# UNITED STATES PATENT AND TRADEMARK OFFICE

APPLICATION NO.	FILING DATE	FIRST NAMED INVENTOR	ATTORNEY DOCKET NO.	CONFIRMATION NO.
10/033,019	12/27/2001	Chen Wei	2470-PAT	7837

### Office Action Summary

## **DETAILED ACTION**

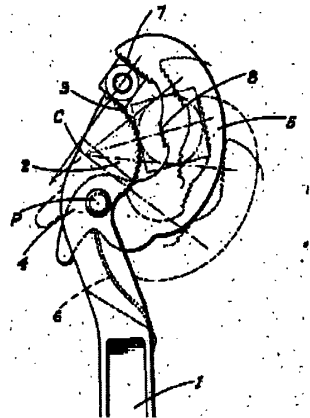
Mead meets all the limitations of claim 1, in Figs. 1 and 2, i.e., a handle (1) having a working end (2) and a gripping end (lower portion), a jaw member (5) rotationally attached to the handle at a fixed point (P), said working end having a continuously curved handle face (3) making a smooth arc centered about (C) adjacent to pivot point, jaw member having a planar surface (7), biasing means (6) to bias the planar face toward the handle face, the planar face following a generally circular path around the pin with a maximum distance from the curved handle face when the jaw is rotated from a first point at a minimum distance, including a surface formed adjacent to the elbow (mid-point between the jaw member) to overcome the bias of the spring (functionally inherent), except for the shape of the tool as recited by the claim, i.e., two struts meeting at an elbow. It is noted that, although, changing shape may be considered obvious to one having ordinary skill in the art at the time dependent on work-piece and/or operational parameters, e.g., cost of manufacturing, lacking any reasons that two pieces meeting at an elbow solves any stated problem or is for any particular purpose and since it appears that the invention would perform equally well with round exterior surface, for the key feature of the invention as originally disclosed, i.e., the planar gripping surface following a second circular path around the curve handle face, which is defined by a substantially smooth arc, is met by Mead, Haberle is cited.

Haberle discloses wrench wherein the outer engaging jaw member is formed by a strut between the fixed pivot point

and an elbow and a second member, which is in an angled engagement with the first. The elbow defining a thumb trigger (28).
